Inver Grove Heights Planning Commission
Tuesday, November 19, 2024 at 7:00 PM
8150 Barbara Avenue, Inver Grove Heights, MN 55077

Planning Commission Report

MEETING DATE:	November 19, 2024
CASE NO:	24-21NCUC
APPLICANT:	BFI Waste Systems of North America, LLC
PROPERTY OWNER:	Same.
REQUEST:	Hold a public hearing on the applications for a Zoning Ordinance Amendment to allow a vertical expansion of an existing sanitary landfill; Conditional Use Permit for vertical expansion of the Pine Bend Sanitary Landfill; and the Non-Conforming Use Certificate Amendment to permit the landfill expansion.
LOCATION:	2495 117th Street East
COMPREHENSIVE PLAN:	General Industrial
ZONING:	I-2, General Industry; IRM-Integrated Resource Management Overlay Zoning District
STAFF CONTACT:	Kris Wilson, 651.450.2511

Client/Project	By	App'd	Issued
BH WASTE SYSTEMS OF NORTH AMERICA, LLC PINE BEND LANDFILL			YJW/JDO
2022 MAJOR PERMIT MODIFICATION INVER GROVE HEIGHTS, MINNESOTA			
Existing Conditions Map (West Half)

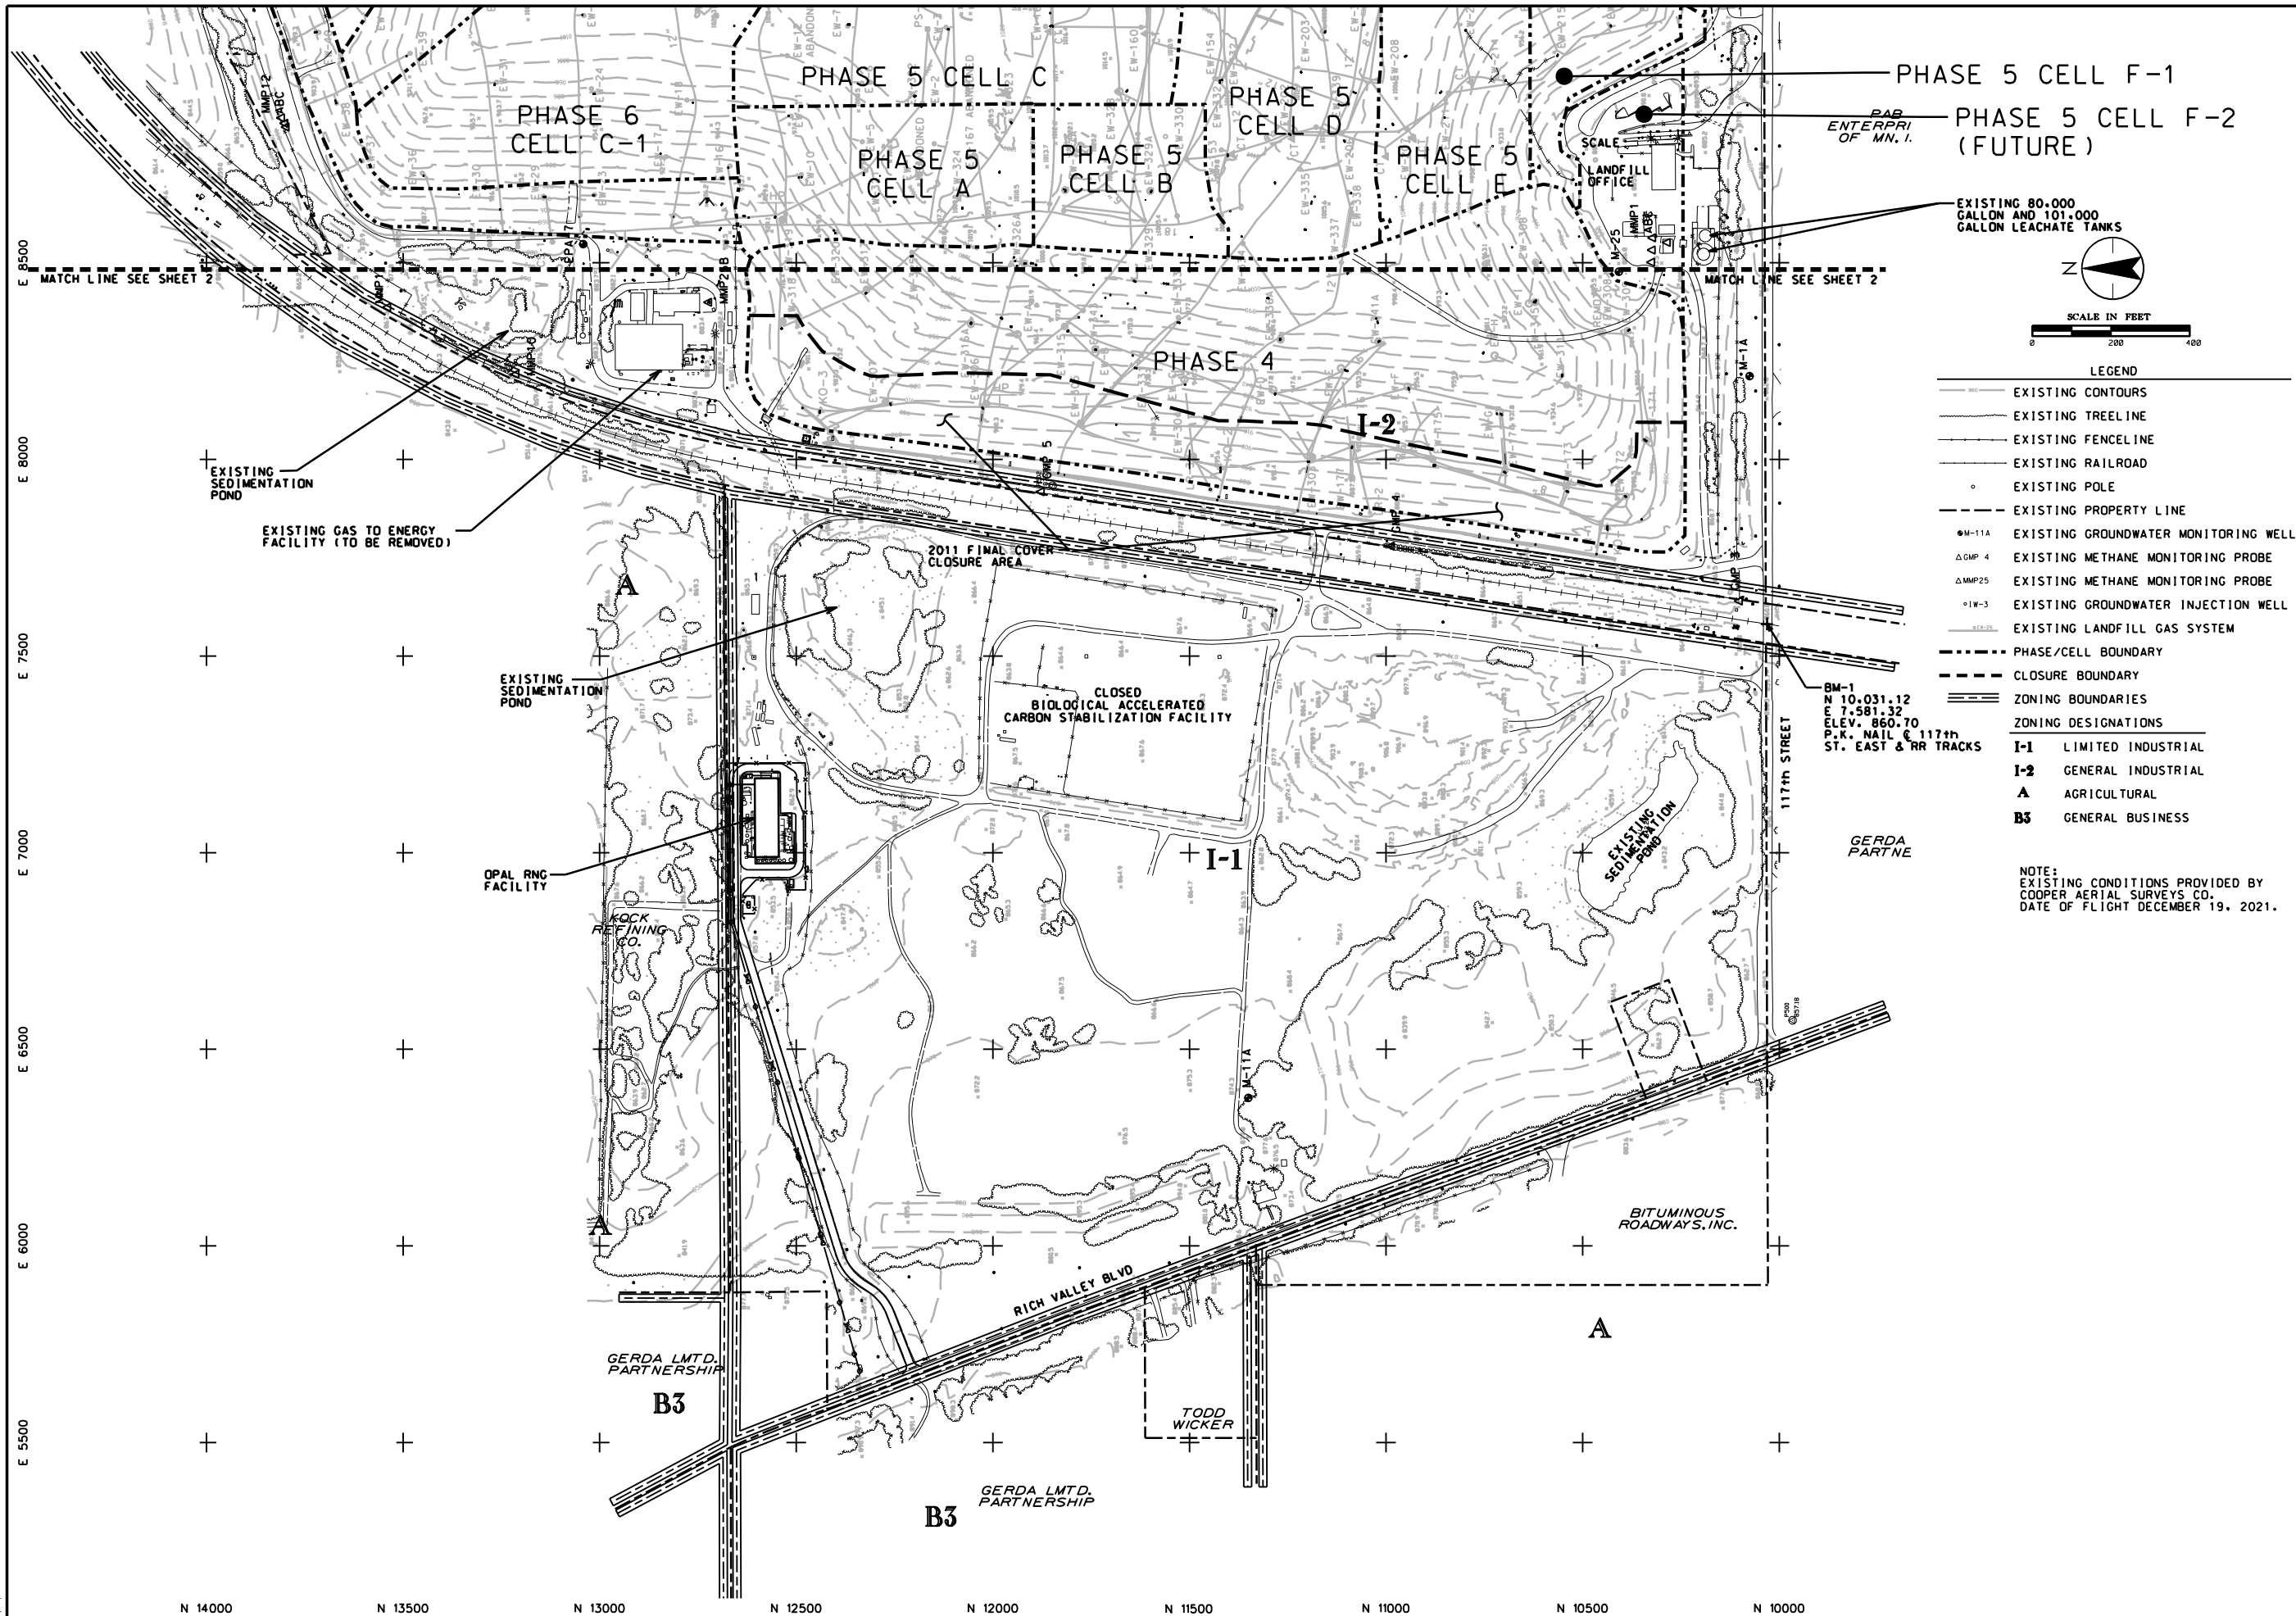
17. *Drawing 2 shows some of the Phase 6 Cells as future cells. Please update.*

2022 MAJOR PERMIT MODIFICATION
INVER GROVE HEIGHTS, MINNESOTA
Proposed Gas Piping Plan - North Half

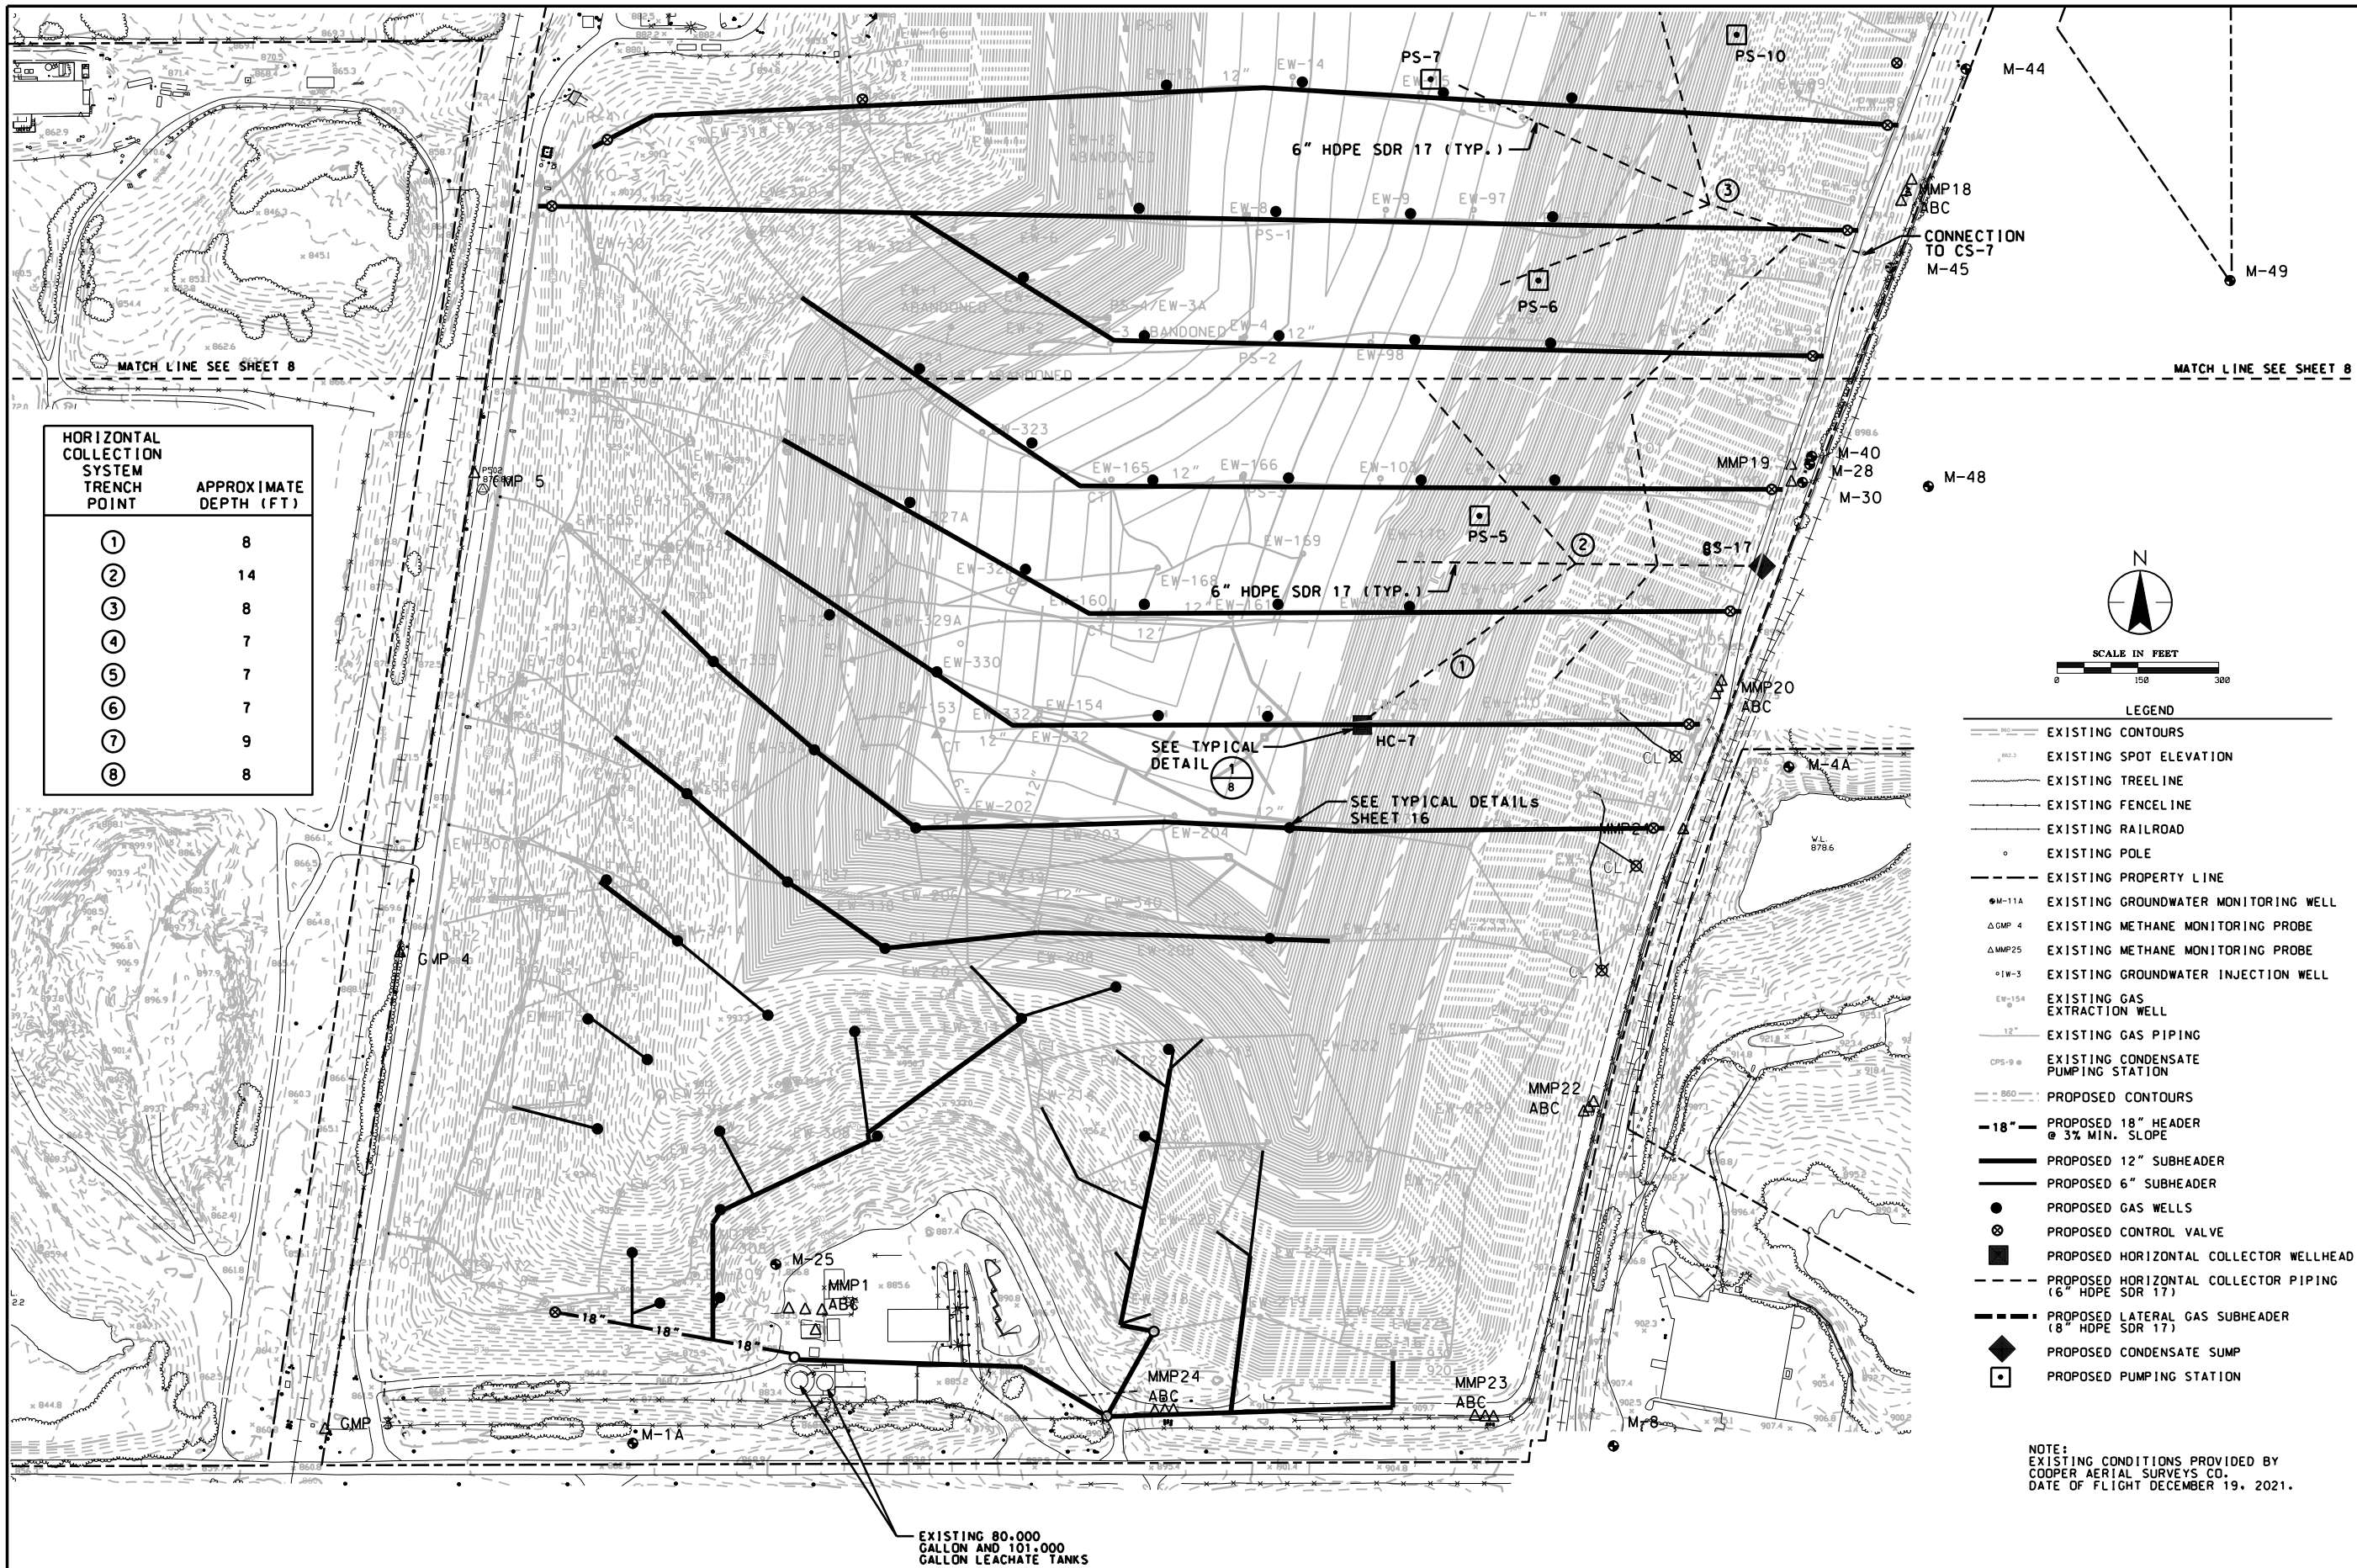
2. Design Report, Section 4.7.4.2 describes the horizontal gas collectors installed in the Phase 6 expansion area. However, no discussion is included about any horizontal gas collectors as part of the Phase 7 expansion although Plan Drawings 8 and 9 seem to indicate that horizontal collectors will be installed as part of Phase 7. Please address this apparent discrepancy.
